Access Compliance Report

Public Rights-of-Way

Intersection ID: 8889	Main Street: BENNETT_ST	Cross Street: N_TRYON_ST	Location: NW
ADA ID: FF56192983F5	Ramp Type: PerpDiag	Initial Pass/Fail: Fail	Overall Compliance: No
		Severity Score: 10

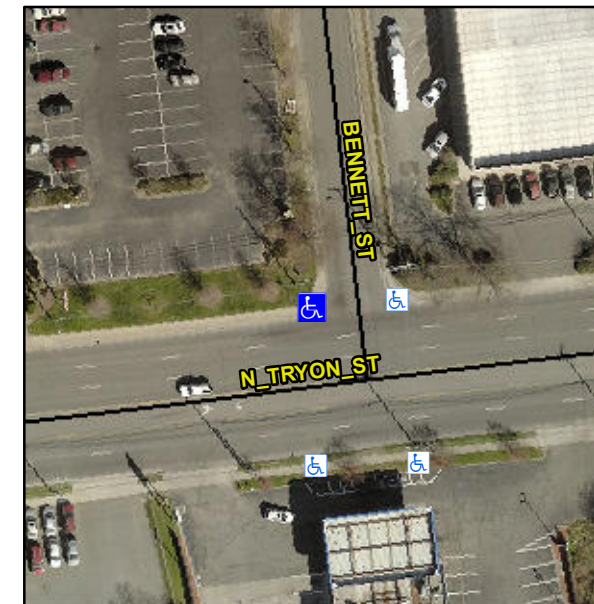
Not Found, R304.5.1, R304.5.3

Compliance	Description	Data	Compliance	Description	Data
N/A	Ramp Length (in)	60.0	Yes	Ramp Slope (%)	5.1
No	Ramp Width (in)	40.0	No	Ramp XSlope (%)	4.4
N/A	Flare Type LT	N/A	N/A	Flare Type RT	N/A
N/A	Flare Slope LT (%)	N/A	N/A	Flare Slope RT (%)	N/A
N/A	Flare Traversable LT?	N/A	N/A	Flare Traversable RT?	N/A
N/A	Landing Length (in)	N/A	N/A	DWS Provided?	N/A
N/A	Landing Width (in)	N/A	N/A	DWS Contrast?	N/A
N/A	Landing Slope (%)	N/A	N/A	DWS Length (in)	N/A
N/A	Landing X Slope (%)	N/A	N/A	DWS Full Width?	N/A
N/A	Landing Curb? (Y/N)	N/A	N/A	DWS Offset (in)	N/A
N/A	Shared Landing?	N/A			
N/A	Gutter Ponding?	N/A	N/A	Gutter Slope (%)	N/A
N/A	Gutter Lip Ht (in)	1.0	N/A	Gutter X Slope (%)	N/A
N/A	Painted X Walk1?	No	N/A	Painted X Walk2?	No
	X Walk 1 Direction	To S		X Walk 2 Direction	To E
N/A	X Walk 1 Width (in)	N/A	N/A	X Walk 2 Width (in)	N/A
	X Walk 1 Slope (%)	4.4		X Walk 2 Slope (%)	2.0
	X Walk 1 X Slope (%)	1.8		X Walk 2 X Slope (%)	5.8

Remove & Replace Curb Ramp With Two New Directional Ramps or Equivalent.
